ADDENDUM No. 1

RFP No. 22-34

WTP HVAC Improvements – Phase II

M-704

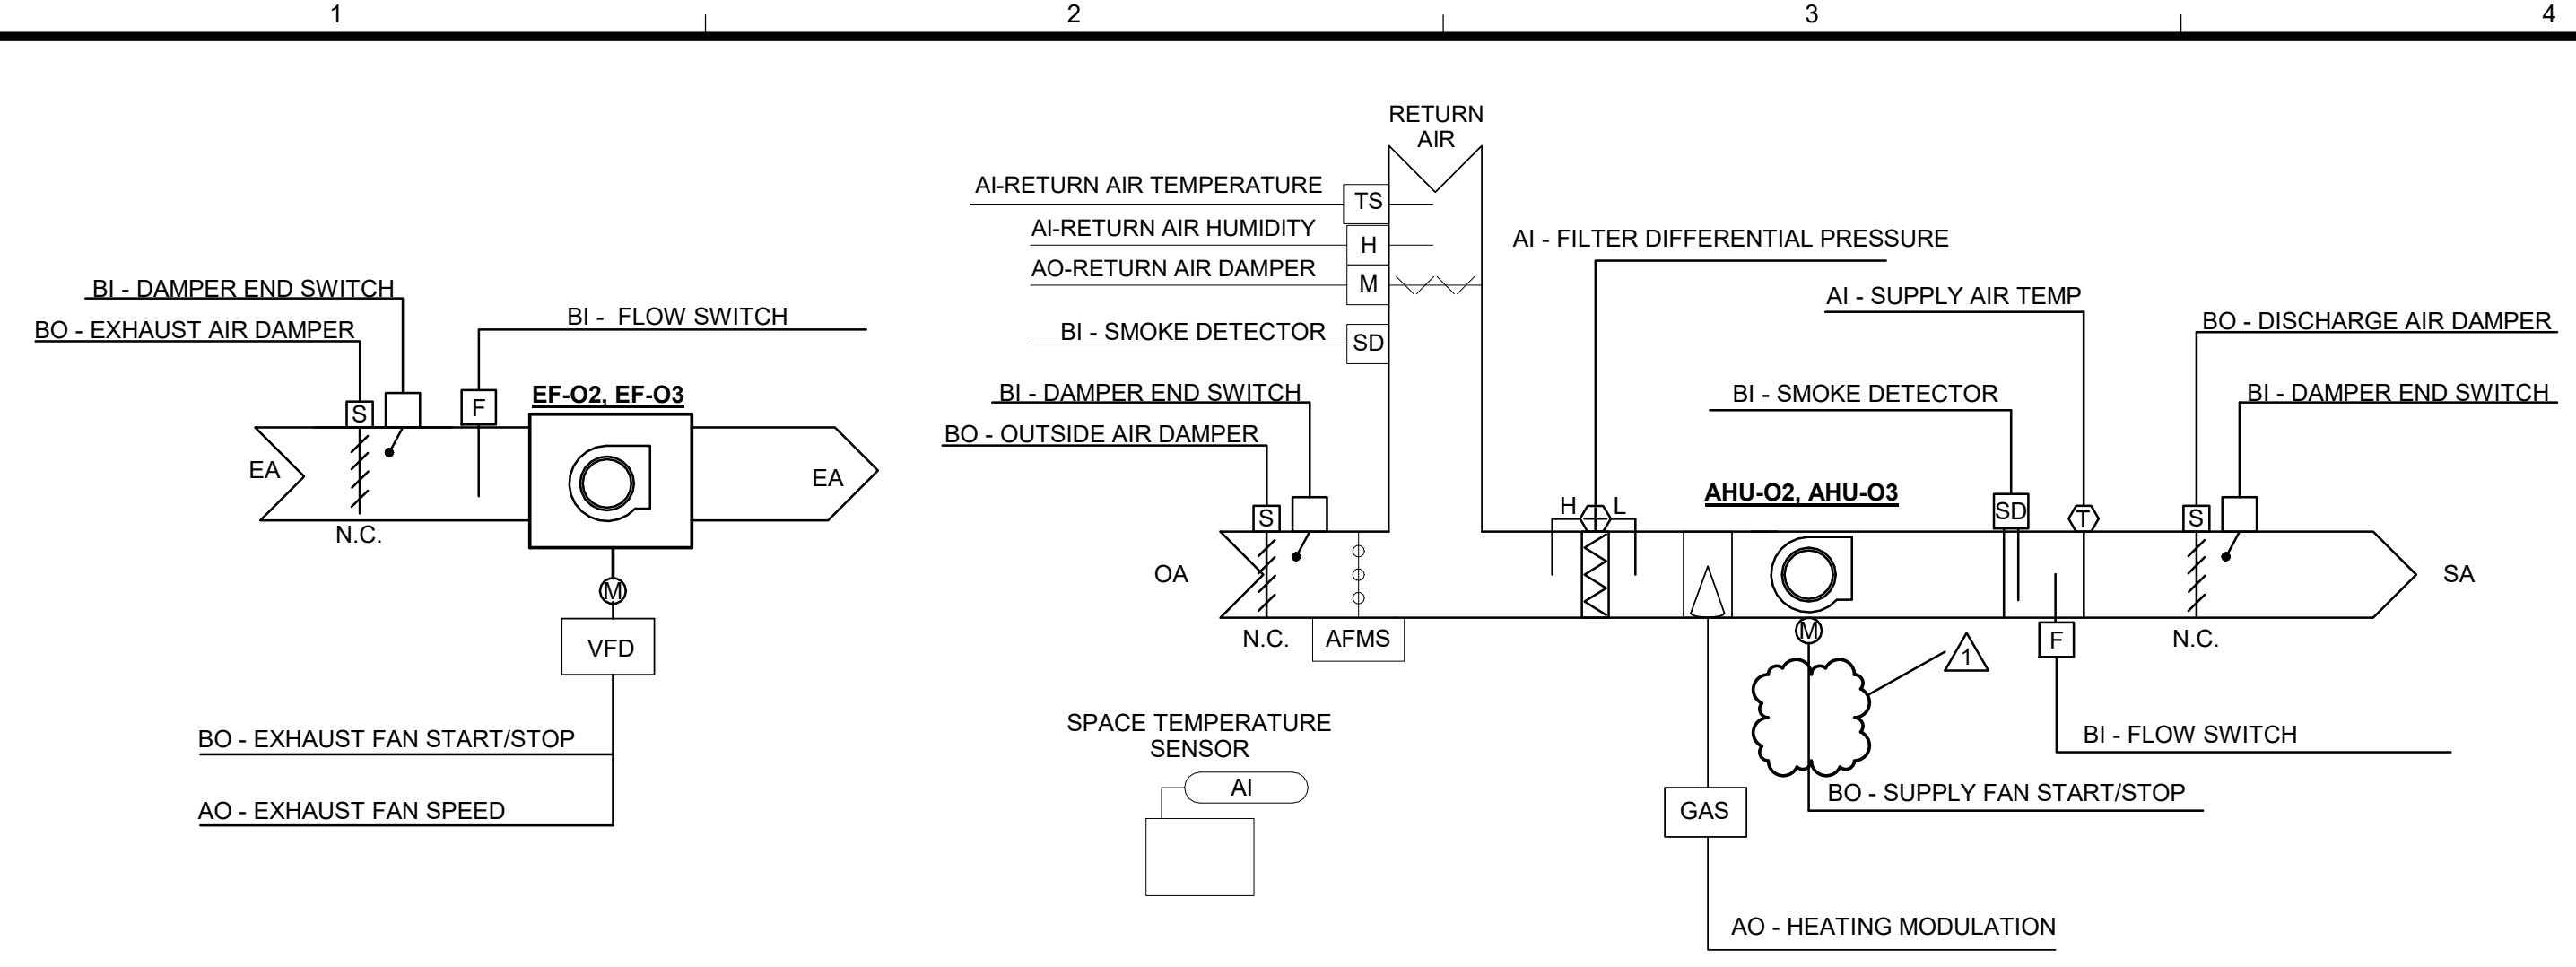
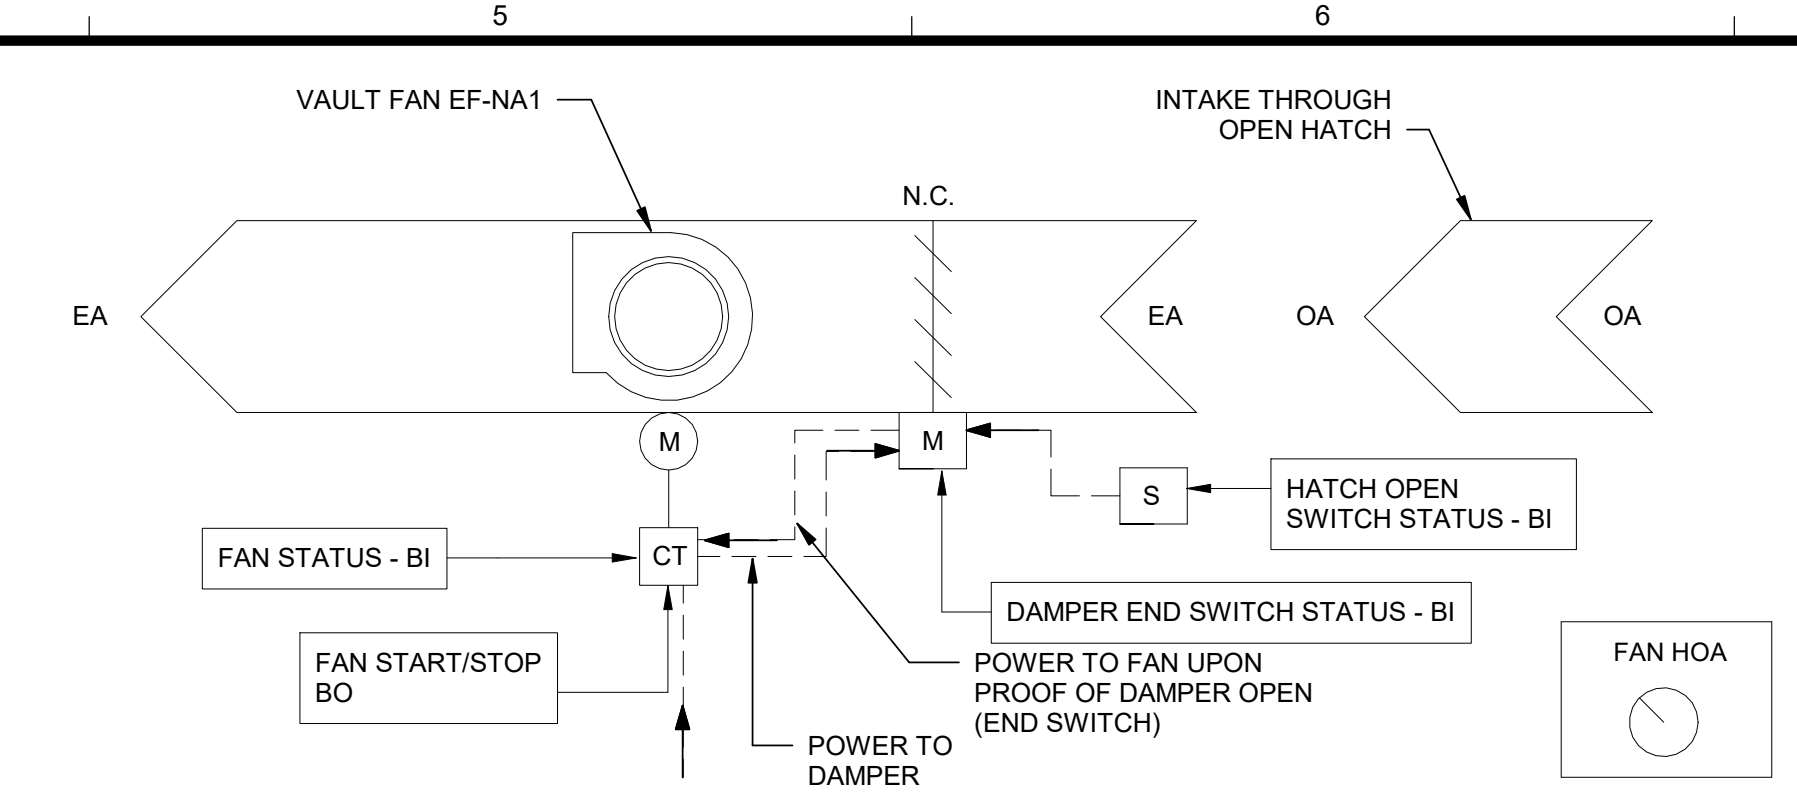
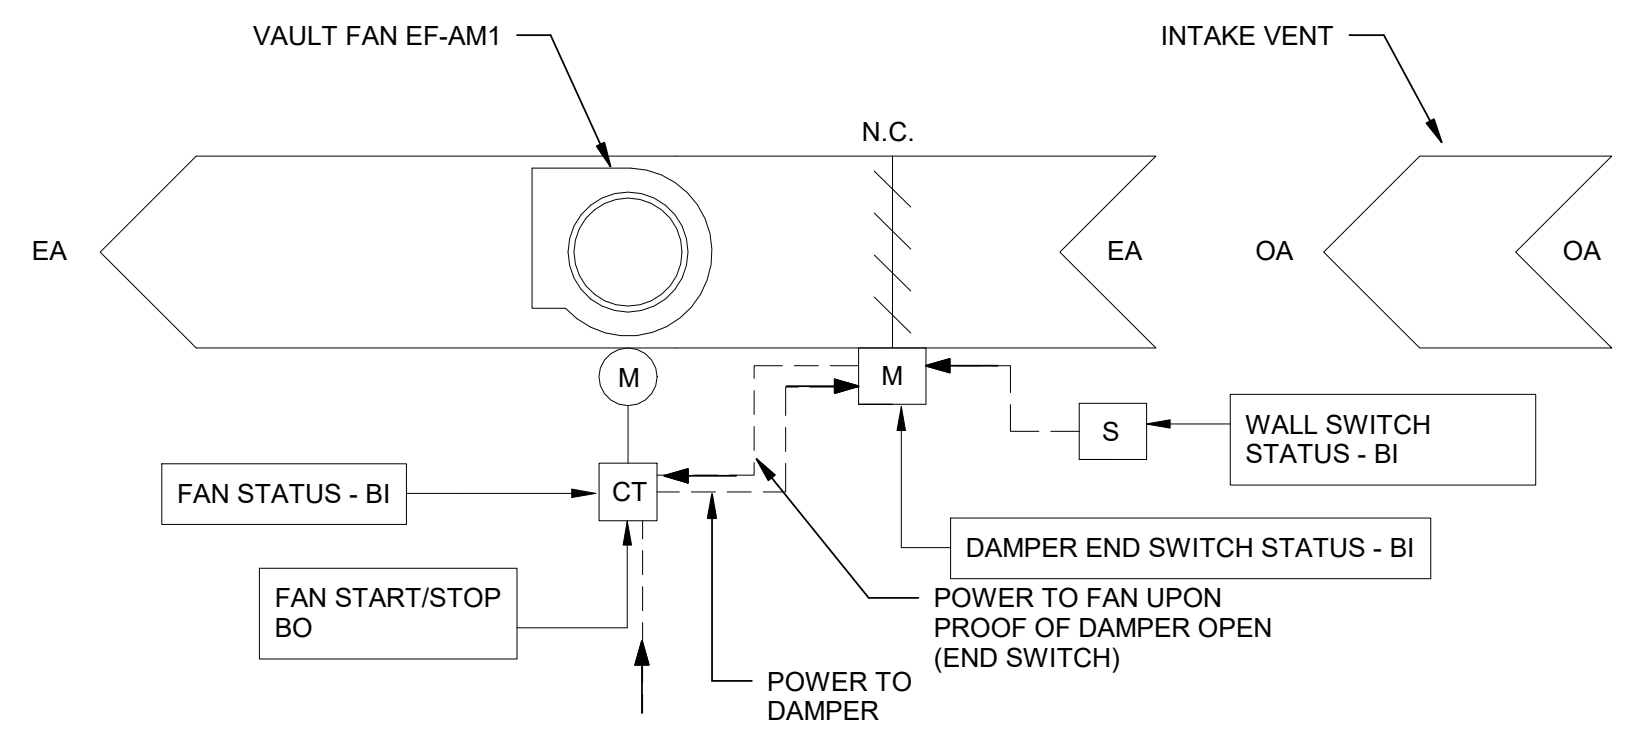
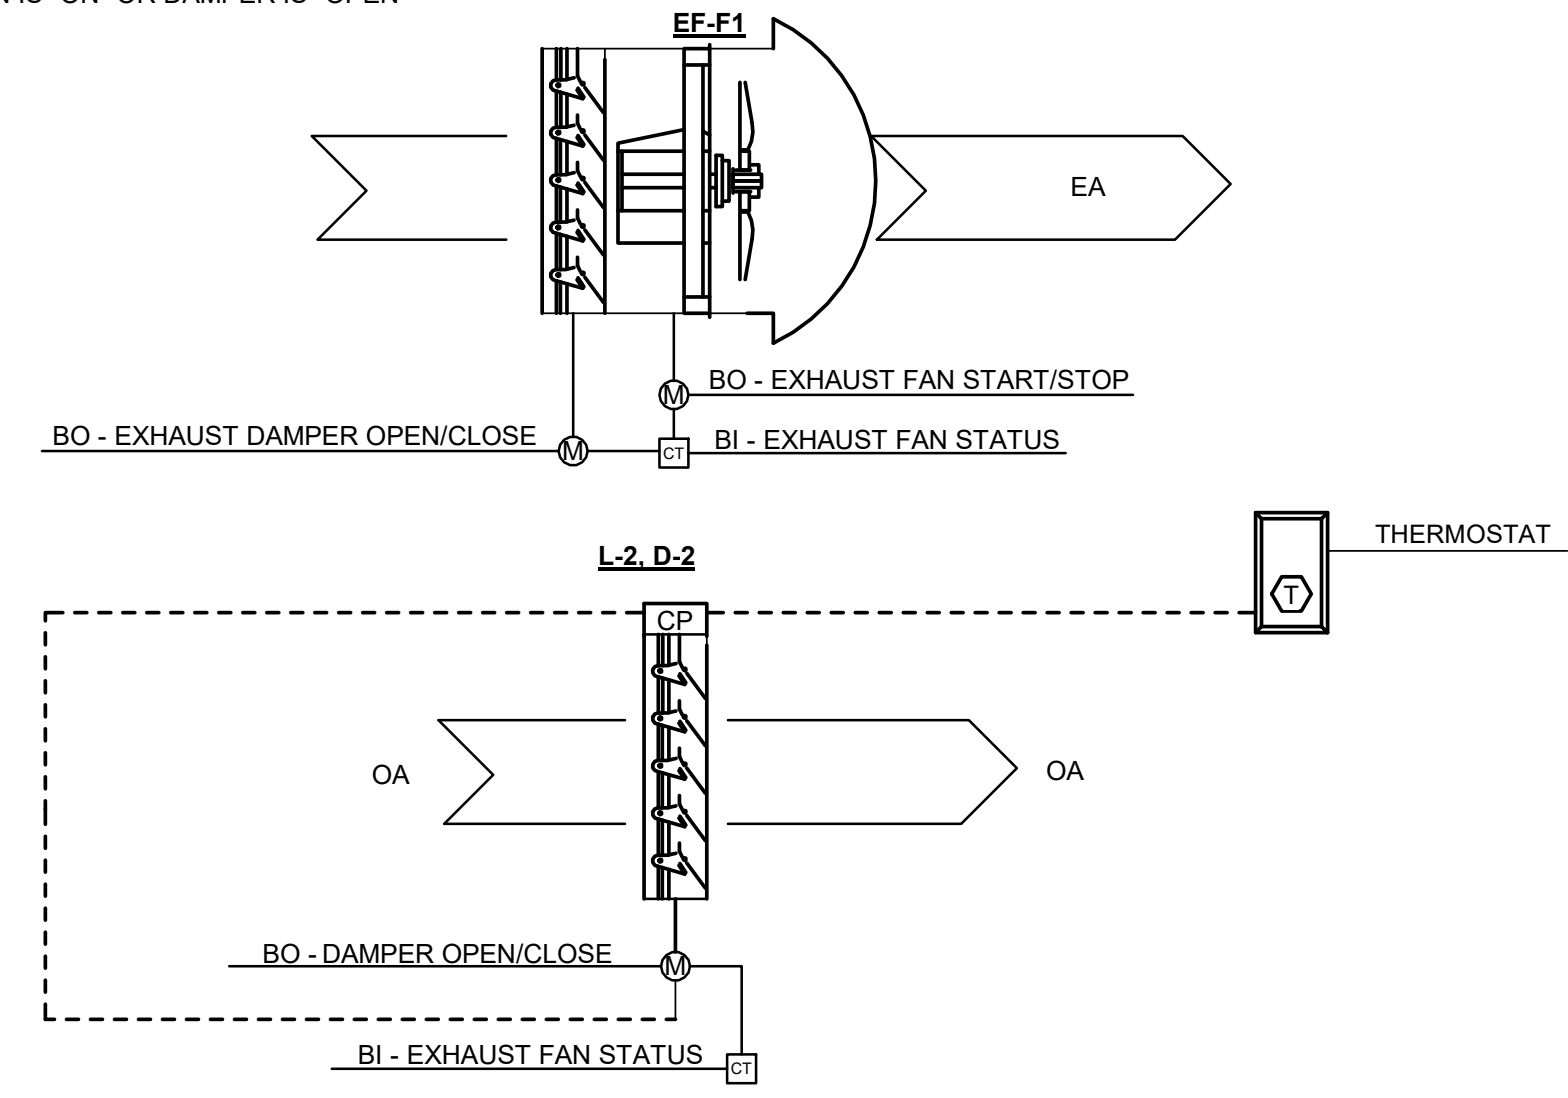
Drawing M-204	On the Chemical Feed Building Fourth Floor/Mezzanine Plan, change Keynote 2 and connection symbol leader lines to point to the east exterior side of the duct chase.
Drawing M-501	Detail 5 removed
Drawing M-701	In Sequence of Operations, change that' "alarms shall be sent to the SCADA system," to, "alarms shall be sent to the plant BMS system."
Drawing M-702	In AHU-1 Controls Diagram and Sequence of Operations, change EF-18 to EF-A4.
Drawing M-703	Reissued
Drawing M-704	Reissued
